AGENDA

Development Commission

- a) **PUBLIC HEARING: Gateway Apartments**
Presented by:
Amy Tarce, Senior Planner
- b) **Public Comment**
- c) **Commission Discussion**

Figure 4. Primary Through Block Passages (arrows) transect the large blocks and provide significant pedestrian routes, creating a finer grid of Circulation Facilities.

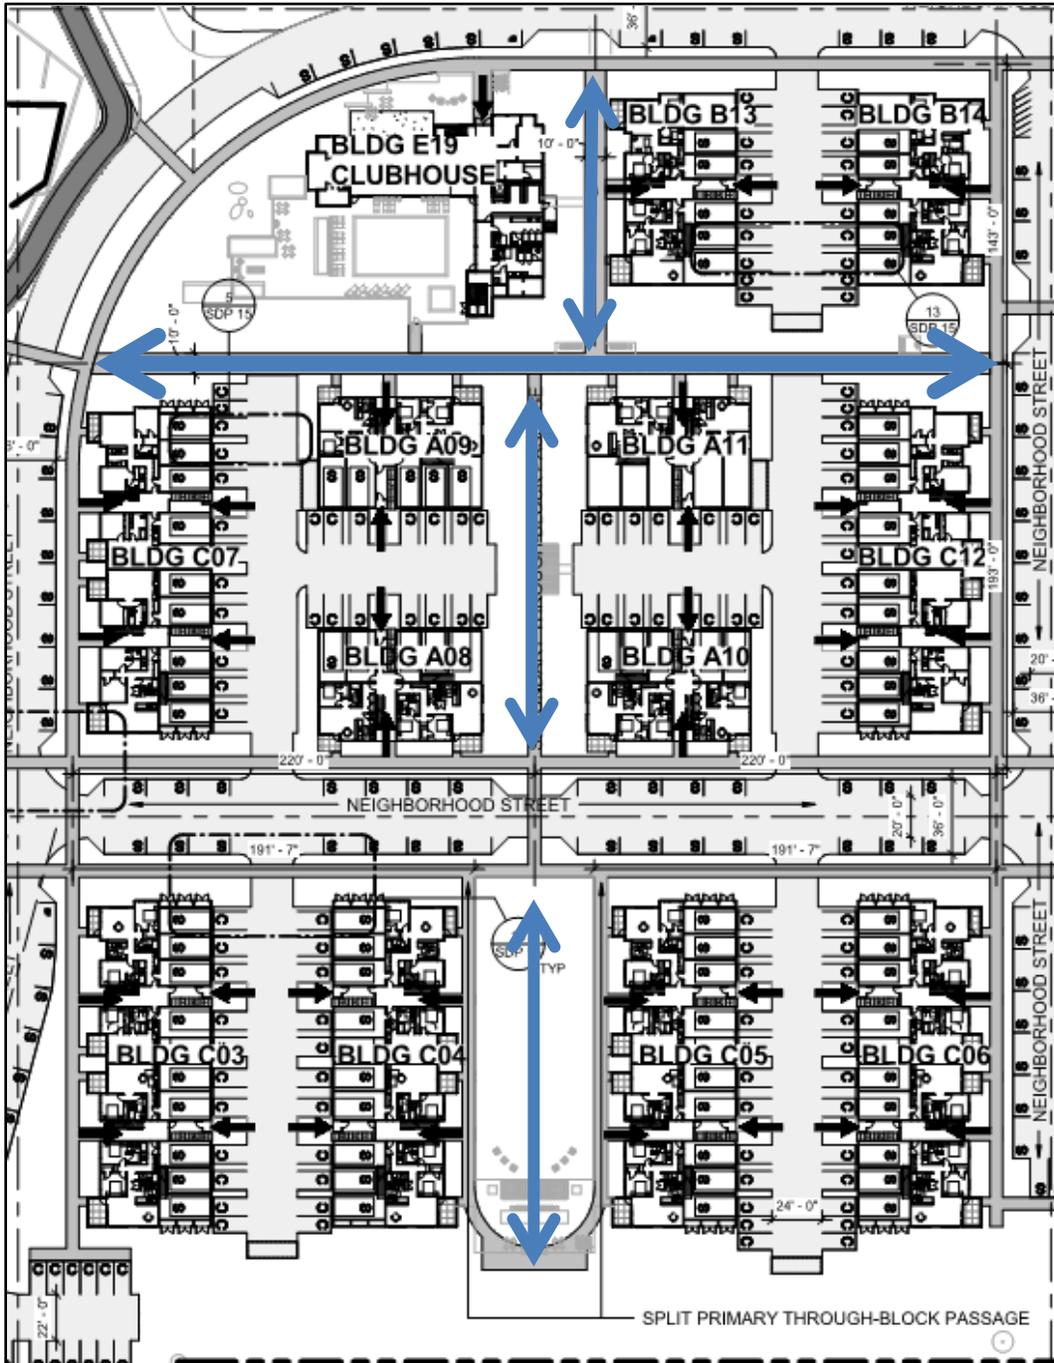
The Primary Through Block Passages serve multiple purposes, including providing a circulation facility on which some buildings front if they do not face a street, breaking up the large neighborhood blocks into walkable lengths, providing major pedestrian linkages to the various community spaces on site, and creating additional open spaces between the residential buildings. These routes comply with the standards, proposing a corridor width of 20 feet and a walkway of 10 feet with landscaping and lighting (see sheet SDP 02 for street classification and sections). Apartments that will front these passages are proposed to have private fenced patios to establish the boundary between public and semi-private spaces along the Through Block Passage. The fences are not primarily for security.

[Condition 8] *The fencing for residential patios fronting Primary Through Block Passages shall be limited to a maximum height of 3 feet.*

Figure 11. Slope analysis for Neighborhood Park (darker area means steeper slopes)

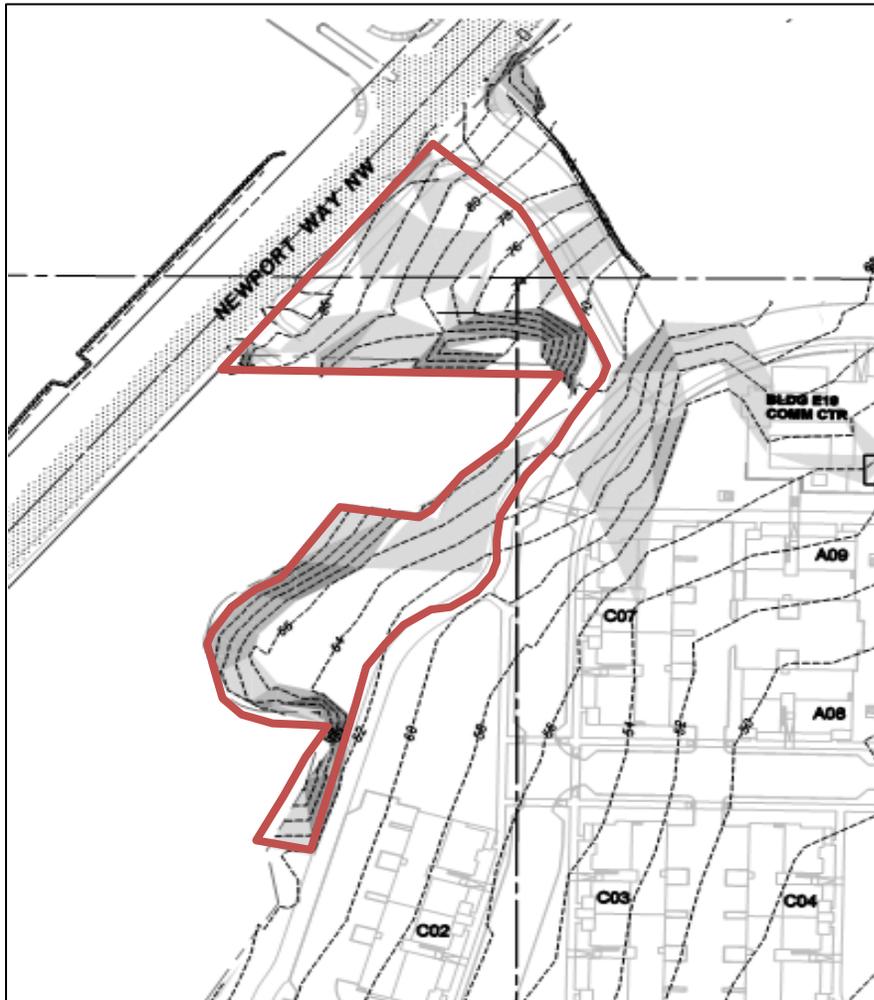
The area proposed for a Neighborhood Park is sloped (see Figure 11 below). The irregular shape of the site and the slopes do not make this part of the project an ideal area for a building site; hence, the area might be considered as “leftover green spaces” unless it is improved as a park. CIDDS 11.3.D.8.d. prohibits “leftover green spaces” for Community Space. The applicant will improve the grading to create areas that are relatively flat and useable for recreational activities.

[Conditions 27, 28, 29, 30]

Figure 12. A 10-foot bike/pedestrian connection should be provided on Newport Way

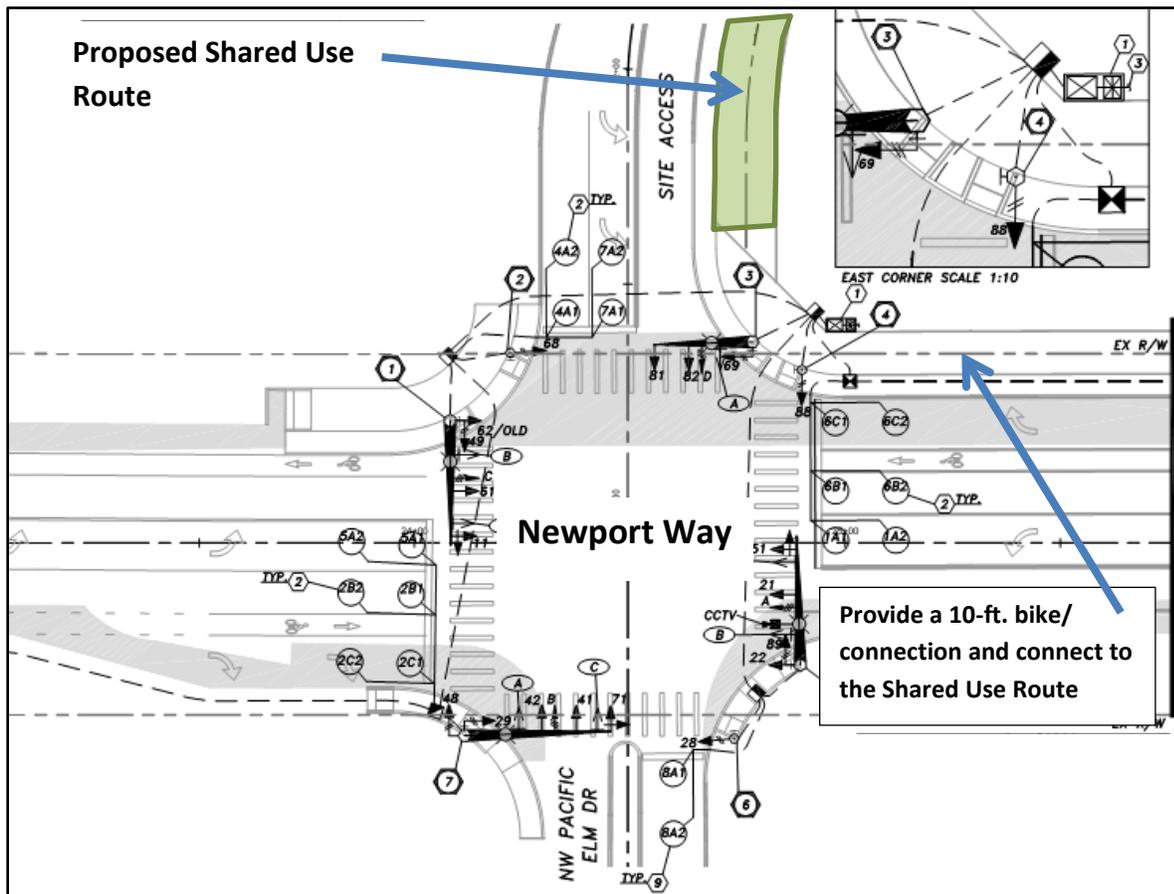
The Neighborhood Park is connected to the natural buffer areas of Tibbetts Creek and Schneider Creek through the network of sidewalks, Through Block Passages and the Shared Use Route that serve the site. Visual cues, such as the 10-foot wide sidewalk/bike connections, park furniture and signage visible from Newport Way, can help the public and the community-at-large know that there are other sections of the park in the interior of the site. Access to nature is not only through the landscaped open spaces in the project. Visual access to hillsides and the Issaquah Alps from the open spaces within the site are also provided.

[Condition 39] Provide a 10-foot wide pedestrian/bike connection along the Newport Way frontage to the sidewalk of the loop road to connect the proposed Neighborhood Park to the existing King County trail east of the project site and the Mountains-to-Sound Greenway

Figure 14. Tandem stall dimensions for parking in the 3-story buildings

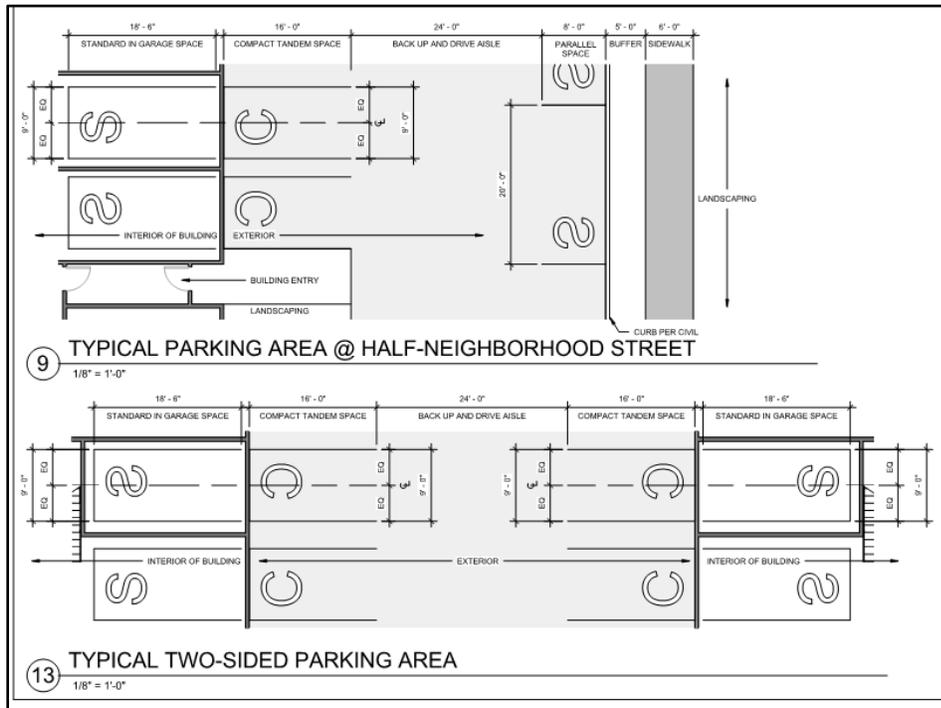
Tandem parking in 3-story buildings: The tandem stalls for the 3-story buildings are not designed like conventional tandem stalls. The proposed tandem stalls are separated by a garage door (see Figure 14). The stall outside of the garage is 9' x 17'. The interior space ranges from 18.5 to 20' in length. The proposed tandem stalls in the shared structured parking include a standard stall measuring 9' x 18.5' and a compact stall at 9' x 16'. The typical drive aisle for double-loaded tandem stalls is 24 feet. The drive aisles in the 5-story garages provide adequate room for large vehicles to overhang into the aisle space without causing any obstruction for circulation and the contiguous parking spaces allow adequate space for 2 standard vehicles to squeeze into the two spaces, if necessary.

Figure 21. Parking areas abut Through Block Passages

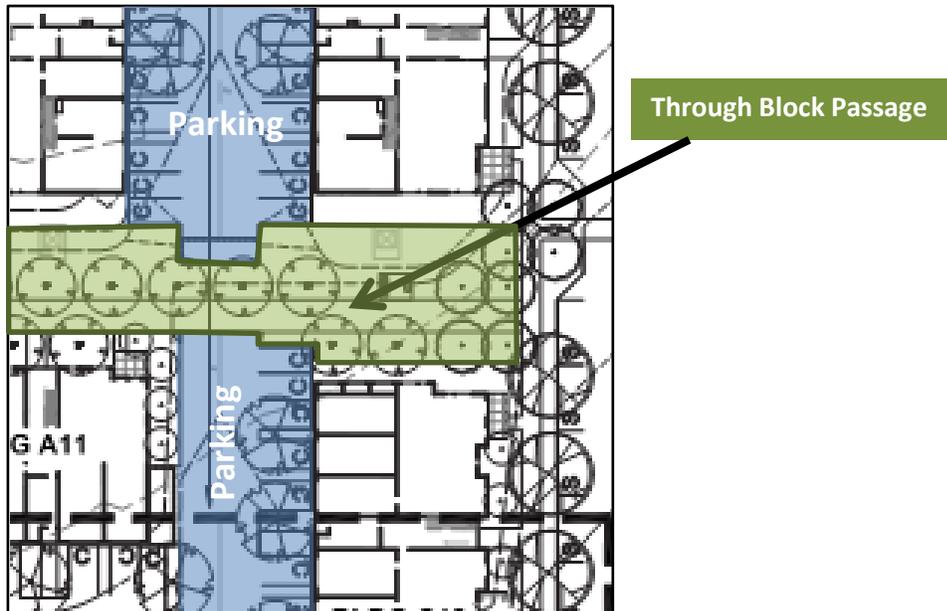
Edge landscaping is required when parking lots abut public rights-of-way, Community Spaces, or Circulation Facilities. Edge landscaping, as prescribed, has a minimum width of 3 feet or substituted with fencing or a wall that is at least 75% opaque. Edge landscaping appears to be missing in many areas where a parking area abuts a Through Block Passage. However, it may be that the Applicant has not fully developed the landscape plan to this level of detail since sheets L1.03 to L1.05 show greater level of details for focused areas that are not shown on the Overall Landscape Plan.

[Condition 53] Where parking areas abut pedestrian circulation or areas, such as the Shared Use Route, Through Block Passages and the termini of the parking area drive aisles at the 3-story buildings, edge landscape at least 3 feet deep or alternative, measured from the curb, shall be provided.

Figure 22. Parking areas visible from the Shared Use Route and Neighborhood Park

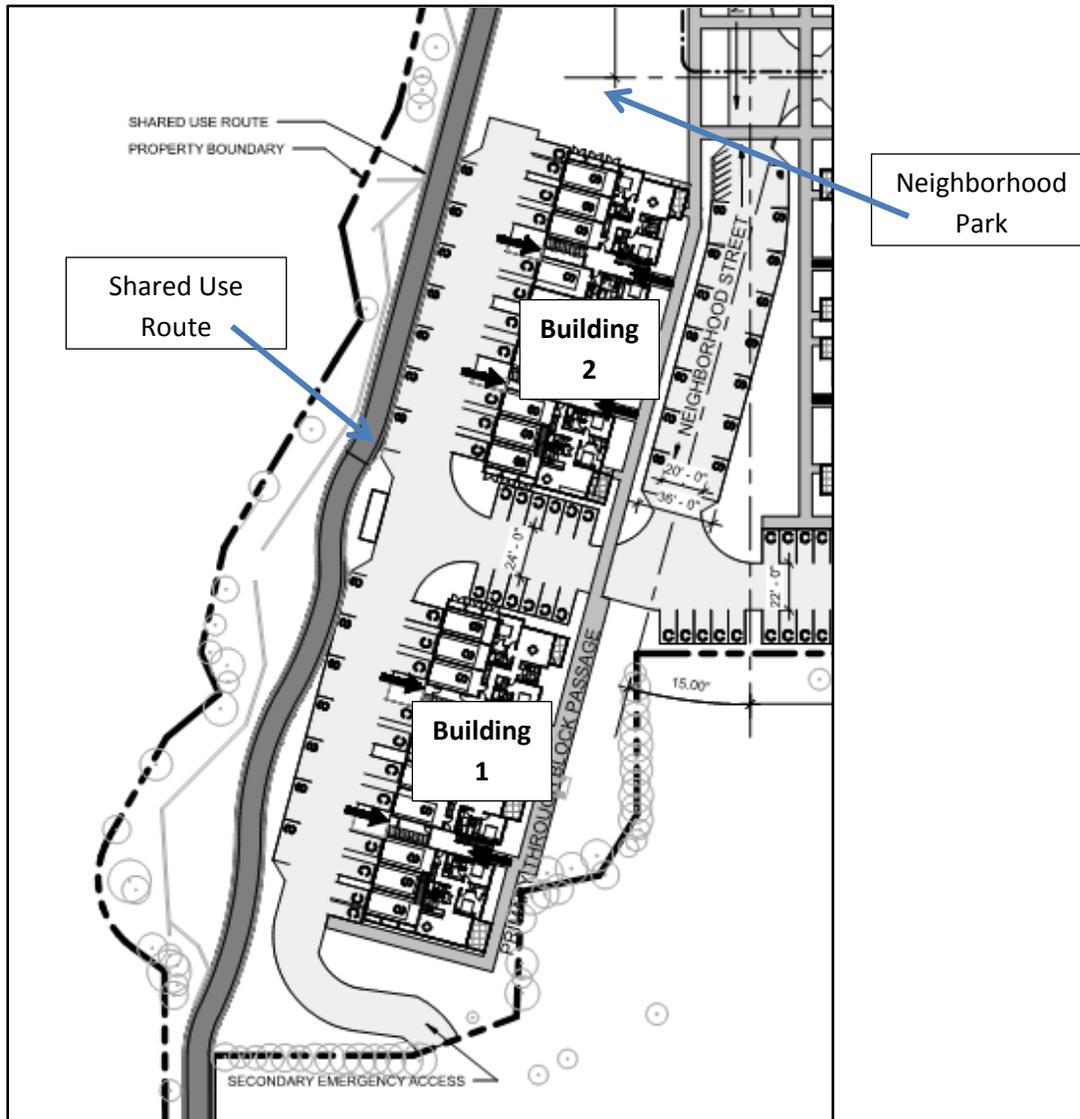
Another area where edge landscaping would be critical is along the Shared Use Route and the Neighborhood Park. The parking area for Building 2 is visible from two public spaces: the Shared Use Route and the Neighborhood Park (see Fig. 22). The parking area for buildings 1 and 2 are entirely visible from the Shared Use Route. Moreover, the Shared Use Route is tucked between the Sammamish Condominiums, retaining walls, and the parking area for the entire length of buildings 1 and 2. Additional clearance is required for the parallel parking as a Shared Use Route only requires 2 ft of landscape along the edge. Locating the parallel spaces next to the Shared Use Route is not safe without additional separation because the car doors will open unto the travel path of pedestrians and bicyclists. There should also be a clear transition between the Shared Use Route as a public facility and the parallel parking spaces that are meant to serve only the residents of the Gateway Apartments.

[Condition 54] Provide at least a 4 feet wide landscape buffer between the parallel parking behind buildings 1 and 2 and the shared use route. Plant material used should be able to survive the high pedestrian traffic and of a height to allow car doors to open into the landscape area without damaging the plants (condition 16.2.L)

Figure 28. Detail plan of the clubhouse showing its relative location to the maximum Build-to-Line (dash line) and outdoor seating visible from the street.

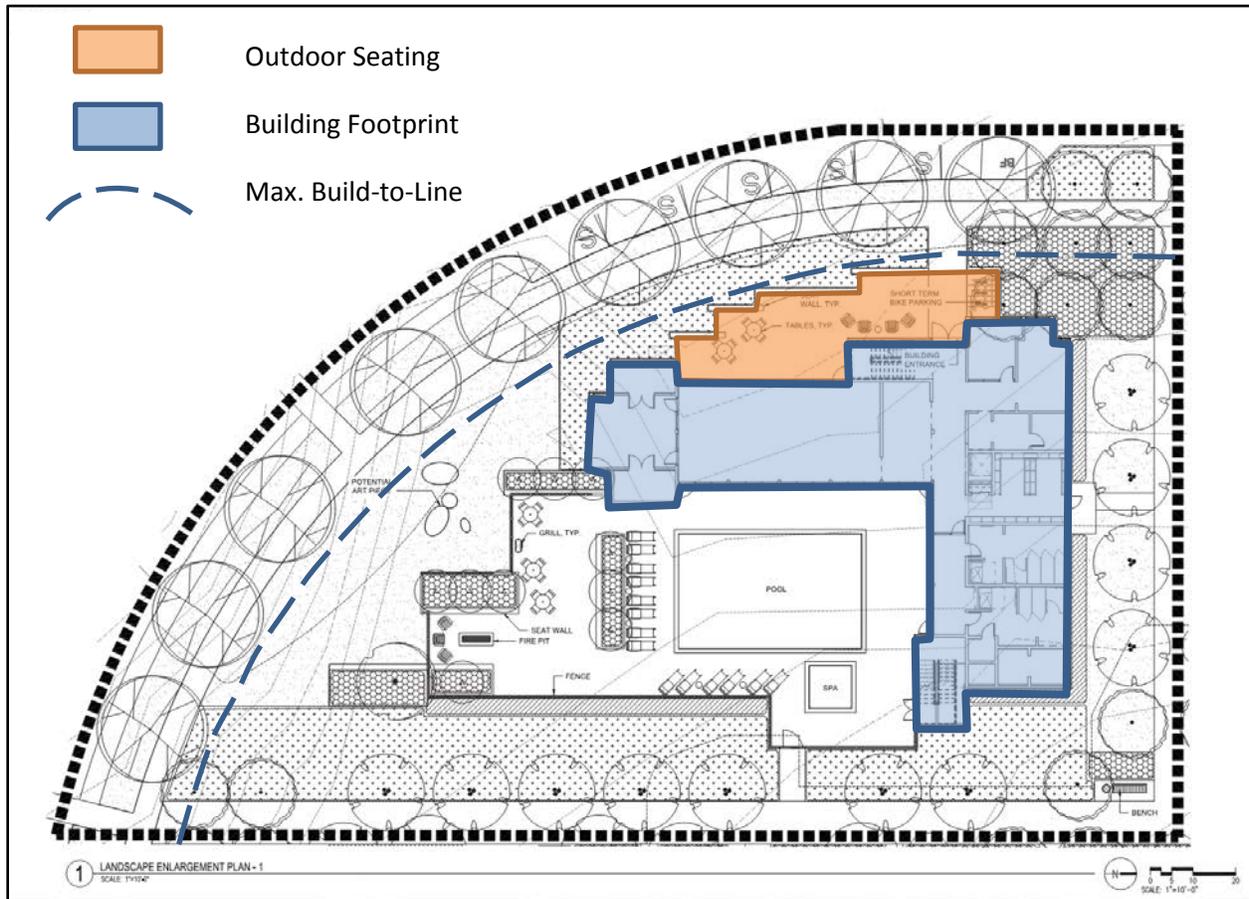
No streetwall is provided at the Newport Way frontage of the property (see sheet L1.18, Schematic Plan Phase 1 of the Neighborhood Park). The full length of the residential buildings sits at the “Build-to-Line” zone, within the allowed 0 to 15 feet, measured from the back of the sidewalk (see sheet SDP 02 for dimensions). The 3-story buildings are located between 5 feet to 10 feet of the back of the sidewalk. The 5-story buildings sit 11 feet from the back of the sidewalks. The community center, however, is recessed beyond the 15 feet maximum “Build-to-Line” and will need to be adjusted. Given the curved configuration of the area where the community center is located, the building was designed to follow the curvature of the street. The shortest distance between the sidewalk and the building face, at the building entry, is approximately 20 feet (please see sheet SDP 02 for site dimensions). In the VR, Village Residential Zone, the required minimum length of the building that should sit on the Build-to-Line is 60%. The community center is designed with most of its street frontage consisting of an outdoor terrace with a low masonry wall and landscaping. It is not clear how the building meets the minimum 60% street frontage requirement. A portion of the outdoor terrace may count towards the 20% building frontage and 10% for a community space such as the outdoor dining area shown.

[Condition 69] The clubhouse or community center building shall meet the streetwall provisions for the Village Residential zone.

Figure 29. Typical locations of trash enclosures in the 3-story buildings (see sheet SDP 05)

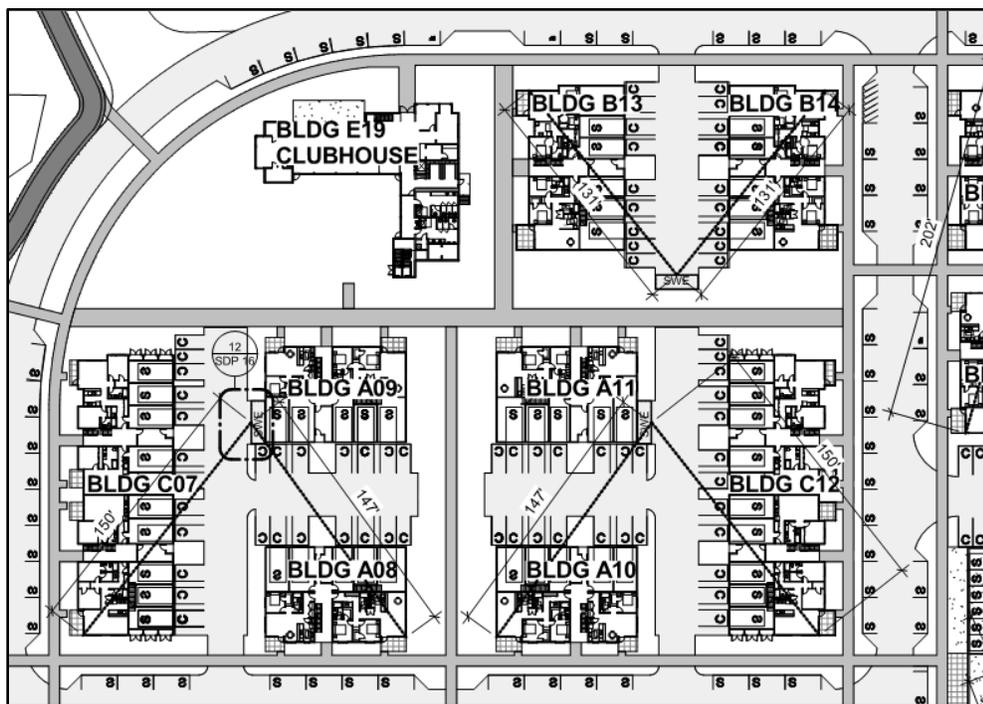
The waste enclosures are located within the parking areas of the 3-story buildings, in lieu of alleys (see Figure 29 below). The location of the enclosures will need to be evaluated further to ensure they don't block pedestrian or vehicular circulation. The waste enclosures for, buildings 15 and 16 may need to be relocated since it appears they will block pedestrian and vehicular traffic (see Figure 30A and 30B below). The waste enclosure for buildings 15 and 16 opens into the sidewalk and will require the dumpster truck to park in the drive aisle of the neighborhood street serving Building 17 and will block the garages of Building 15.

[Condition 73] Relocate the waste collection/trash enclosure for buildings 15 and 16.

Figure 30A, left, shows the location of the trash enclosure for buildings 1 and 2. Figure 30B, shows the location of the trash enclosures for buildings 15, 16 and 17.

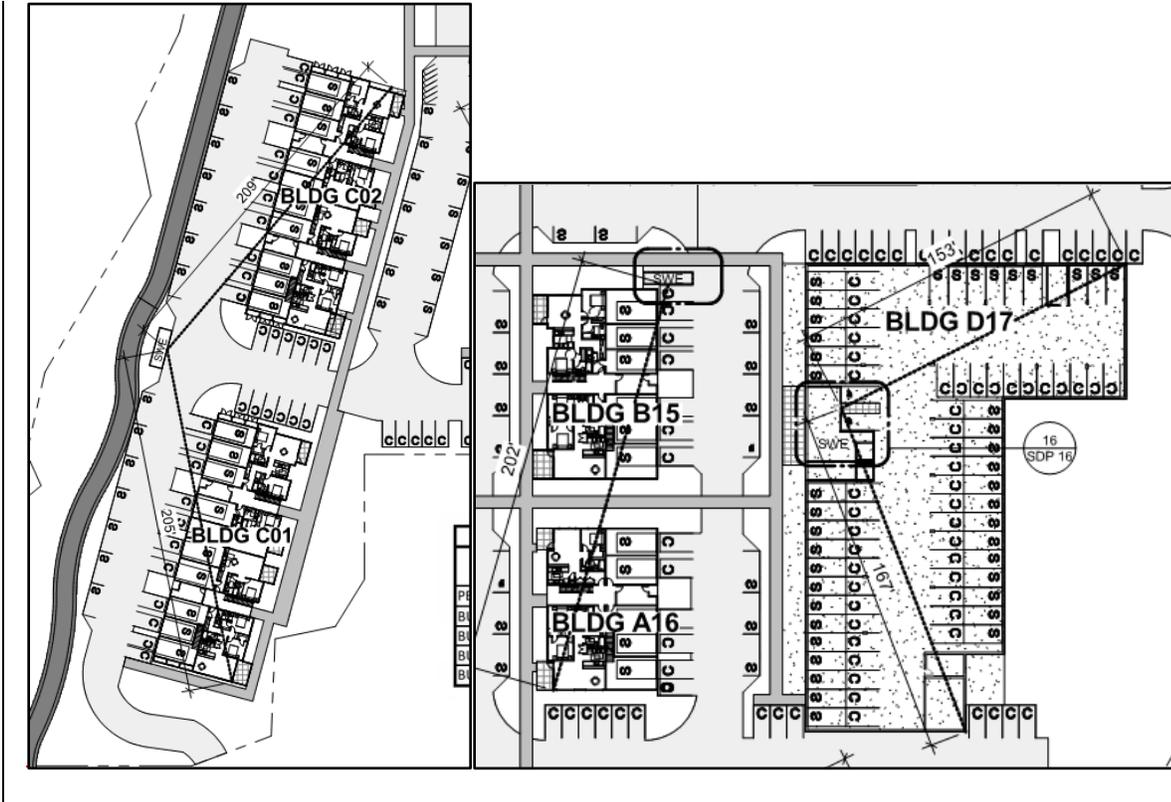
Loading areas for the two 5-story buildings are provided across from the garage entries, and the solid waste storage areas are located inside the respective garages (see Figure 30B and sheet SDP 05). No loading areas are provided for the 3-story buildings and waste enclosures are consolidated for the 3-story buildings consistent with the dispersion requirements for waste enclosures per other city standards.
